Exhibit A1
Staff Report
Canyon Creek Phase 3 Subdivision – 5 & New Residential Lots

Development Review Board Panel 'A' Quasi-Judicial Public Hearing
Amended and Adopted May 11, 2021
Added language ***bold italics underline***
Removed language ~~struck through~~

Application Nos.: DB20-0040 – Comprehensive Plan Amendment
DB20-0039 – Zone Map Amendment
DB20-0041 – Stage I Master Plan
DB20-0042 – Stage II Final Plan
DB20-0043 – Site Design Review
DB20-0044 – Type C Tree Plan
DB20-0045 – Tentative Subdivision Plat
~~DB20-0053 – Waiver~~

Previous Usable Open Space Location (Tract A)

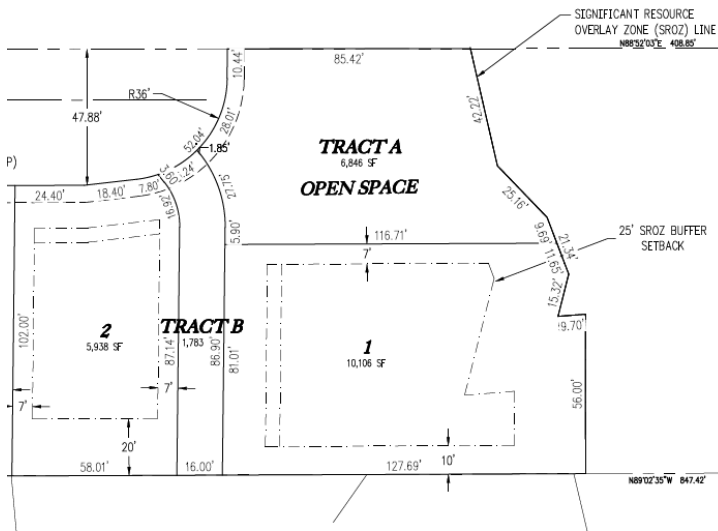
The applicant proposes an open space area (Tract A) which provides ~~7,691~~ 6,729 square feet of usable open space. ~~The usable open space area provides a pedestrian connection into the open space area from the public sidewalk, a preserved tree, a stormwater facility, a community garden, and an open play area. The applicant has included a completed affidavit form attesting that the usable open space area has been designed by a registered landscape architect with experience designing similar usable open space areas within residential areas.~~ At the time of writing this staff report, only the size and general shape of the required usable open space area has been submitted to staff. The layout, amenities, and overall appearance including landscaping are subject to the Site Design Review criteria and are intended to be reviewed by the Development Review Board. It is unlikely the applicant can provide Staff with a professionally designed landscape plan and affidavit prior to the continued hearing date of May 10, 2021. In order to ensure the future open space meets Site Design Review criteria and requirements for Open Space areas contained in Section 4.113, staff has conditioned that the final design of Tract A return before the DRB for final approval.

On April 29, 2021 the applicant sent staff a revised subdivision plan that includes a newly configured open space area (Tract A) which now provides 6,729 square feet of usable open space. The location of the open space is more appropriate than the previous proposal and allows clear sightlines into the usable open space area and adjacent natural area. Due to the time constraints involved in revising the open space to meet the requirement that it be designed by a registered landscape architect, the open space has been conditioned to return to the DRB for final design approval.

<p>PDD 14. <u>Prior to Final Plat Approval:</u> The applicant shall submit a revised Sheet L1 showing the landscaping plan to match the new shape and square footage of the proposed usable open space area in Tract A. <i><u>If the project landscape architect changes, the applicant shall submit a new Affidavit of Professional Credentials for Residential Usable Open Space Areas in the City of Wilsonville. For final approval of the revised open space area, the applicant shall return to the Development Review Board for review of the redesigned open space.</u></i> See Finding D49.</p>
<p>PDD 15. <u>Prior to Final Plat Approval:</u> The applicant shall revise the CC&R's and Bylaws documents to require the future Homeowners Association to actively enforce no parking areas, tow any illegally parked vehicle within 12 hours, and establish fees for homeowners who violate the no parking zones. See finding D37.</p>

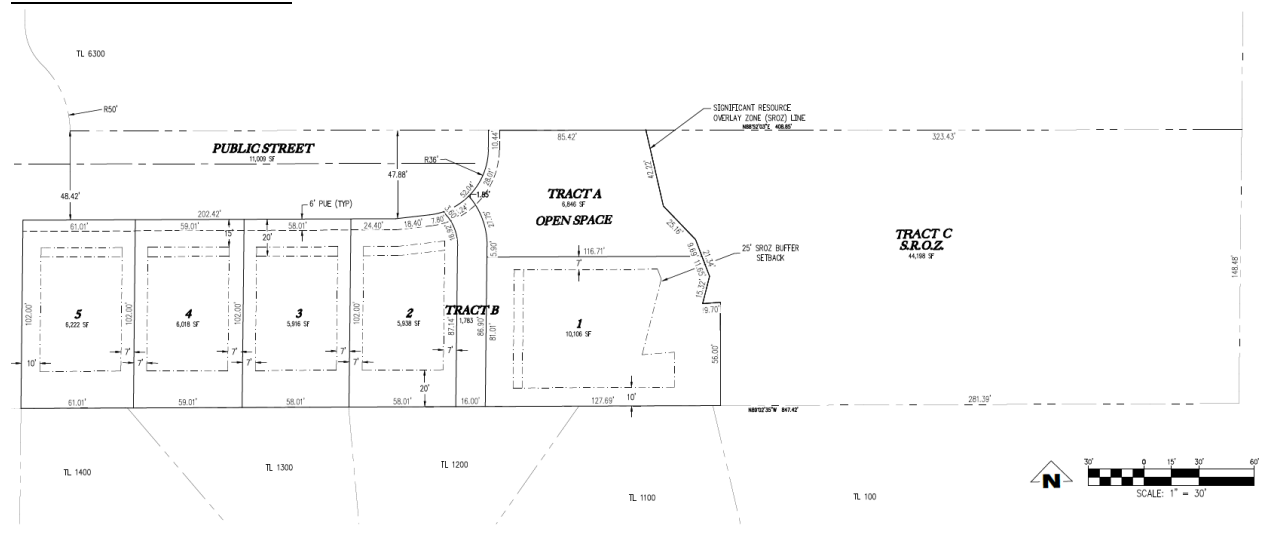
internal side yards of lots 2 and 4-7 for two-story homes. The applicant also requests a 7-foot setback on the western side of Lot 8 where 10 feet is required for corner lots by the development code in Section 4.113 Standards Applying to Residential Developments in Any Zone.

A revised layout submitted to the City on April 29, 2021 no longer shows the requested side yard setbacks that necessitated a waiver. The Applicant no longer requests the waiver application. The DRB therefore will not approve any of the previously requested waivers.

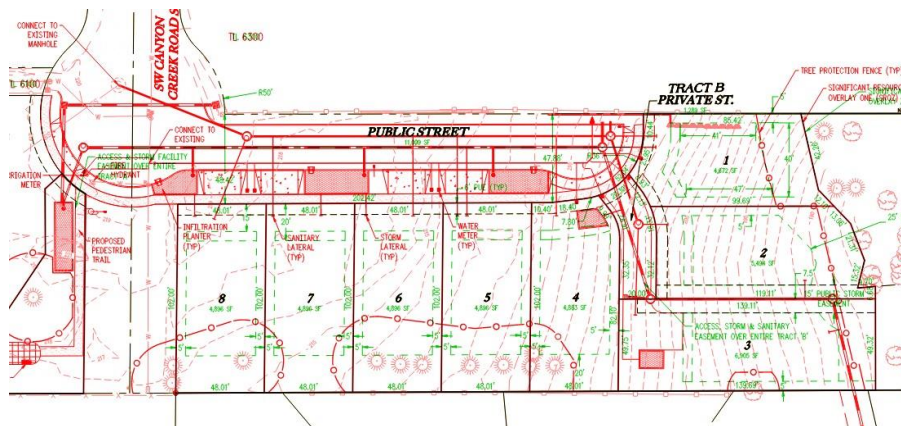
However, the arborist report notes that several of the trees shown as preserved along the rear lot lines for lots ~~2-5~~ 4-8 should be reevaluated against the future home plans as the tree protection fencing overlaps with the buildable area of the proposed lots (shown in the image below delineated by green dashed lines). It is important the tree protection fencing is realistic and easy to maintain as fencing ensures construction impacts will not impact the root zones of the trees and increases the likelihood the preserved trees will survive after construction is complete. Staff has witnessed similar situations in other projects and in order to preserve the trees to the greatest extent possible, a condition of approval has been added to reassess the trees with the project arborist when the future house plans are provided to ensure maximum preservation. In the case that tree removal is requested for one of the trees indicated for preservation, the project arborist will submit a report to City Staff including a written explanation of the measures considered to preserve the trees along with the reasoning that makes preservation not feasible.

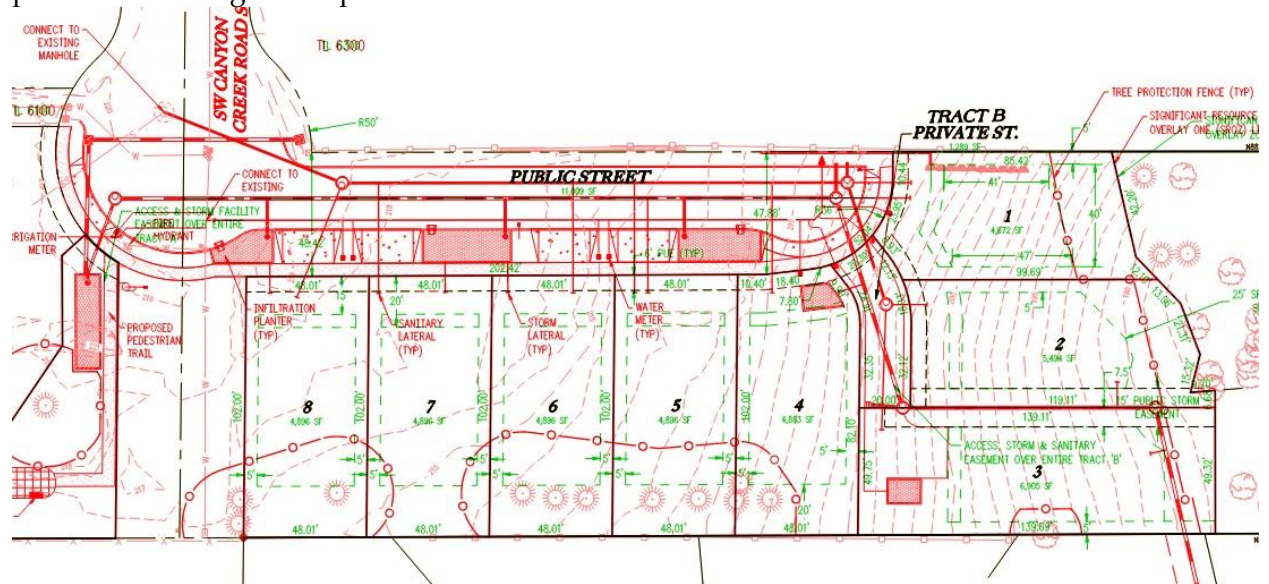
Based on when the arborist report was written, the lot numbers do not reflect the current proposal and lot numbers for the final site plan. Based on the proposed plans and arborist report, staff has concerns regarding the trees proposed for retention at the rear of lots 2-5 3 —8. The image below overlays the proposed preliminary site plan and preliminary plat and clearly shows significant overlap between the tree protection fencing and the delineated buildable area of the lots. The trees are depicted directly adjacent to the potential building envelopes.

Staff questioned the applicant on the proposed tree preservation plans as they relate to the construction of future homes on the newly created lots. The applicant’s response contained in Exhibit B5 states: “The submitted tree preservation and removal plan is specific to the construction of the subdivision only and does not include potential tree removal to accommodate the future homes. Any necessary tree removal required for lots 4-6 and 7 to accommodate future dwellings will be addressed during the building permit review process.”

By time of this staff report publication, the Applicant did not submit new exhibits showing modified building envelopes. Nor did the Applicant submit new findings and exhibits to modify the tree removal and protection plan as a result of a reduced buildable area that would not be feasible. As such, staff has included Condition of Approval PDF 9 that requires an assessment and written report by an arborist if any of these preserved trees are proposed for removal in the future due to construction; the report must provide a written explanation of the measures considered to preserve the trees along with the line of reasoning that prevents preservation, submitted to City staff, who will verify the validity through review by a second arborist.

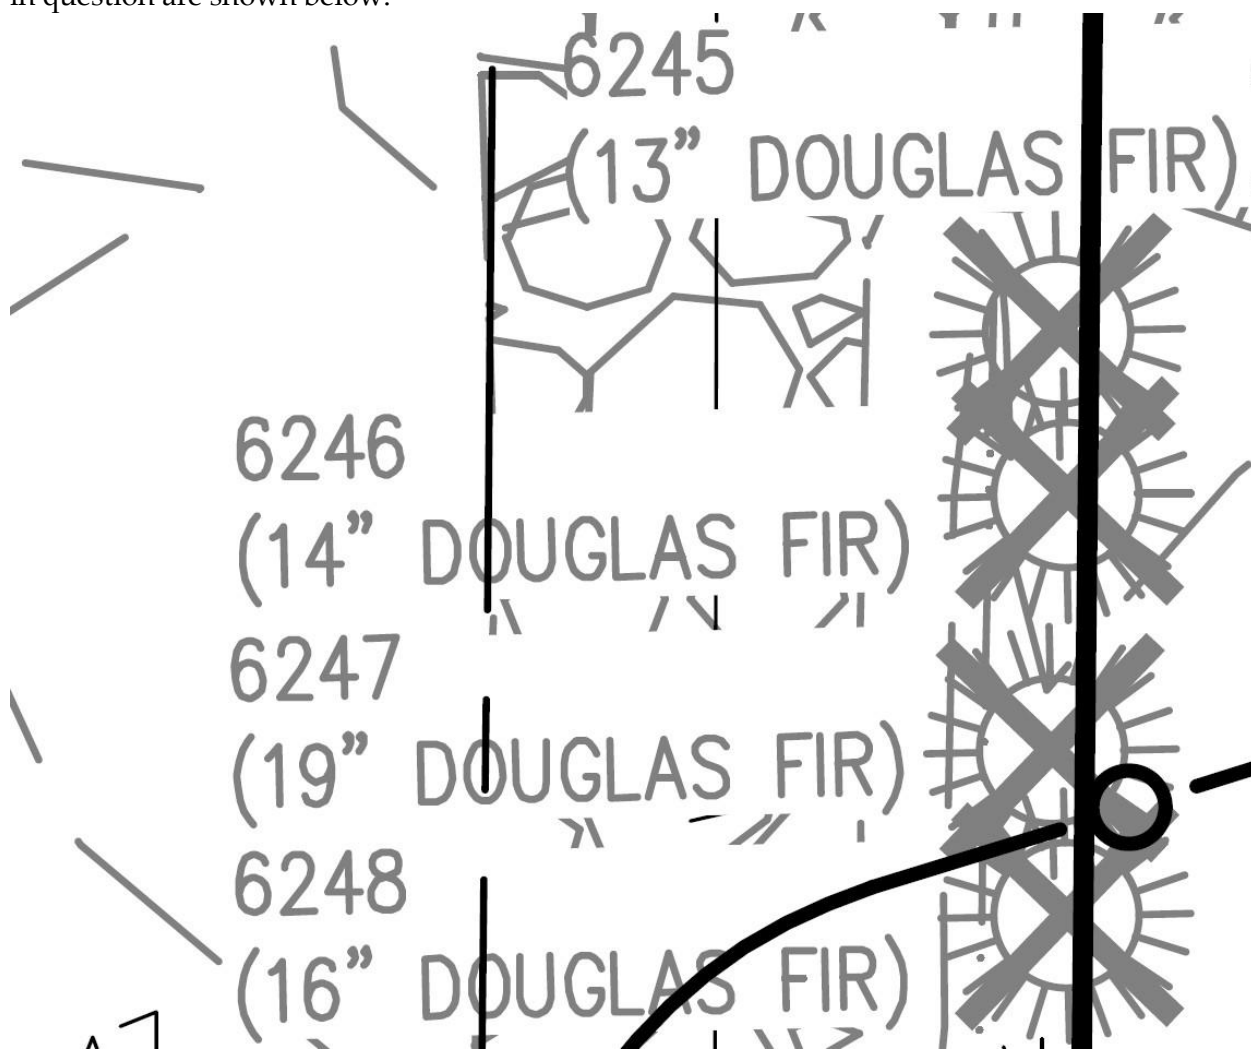
In addition to the issues concerning the trees at the rear of lots 2-5 4-8, the trees proposed for removal along the western property line of Lot 8 appear to be on City of Wilsonville property and the applicant does not have City permission to remove these trees. The trees in question are shown below:

Condition of approval PDF 8 requires Tree Numbers 6245 (13" Douglas Fir), 6246 (14" Douglas Fir), 6247 (19" Douglas Fir), and 6248 (16" Douglas Fir) shall be retained unless City approval and signature is granted for these four (4) trees. The applicant shall revise the tree protection fencing plan to ensure these trees are properly protected during grading and construction. Should these trees require removal in the future due to construction, the applicant shall provide an assessment from an arborist as outlined in Condition of Approval PDF 9, and may be removed if City Staff and an independent arborist concur that removal is necessary.
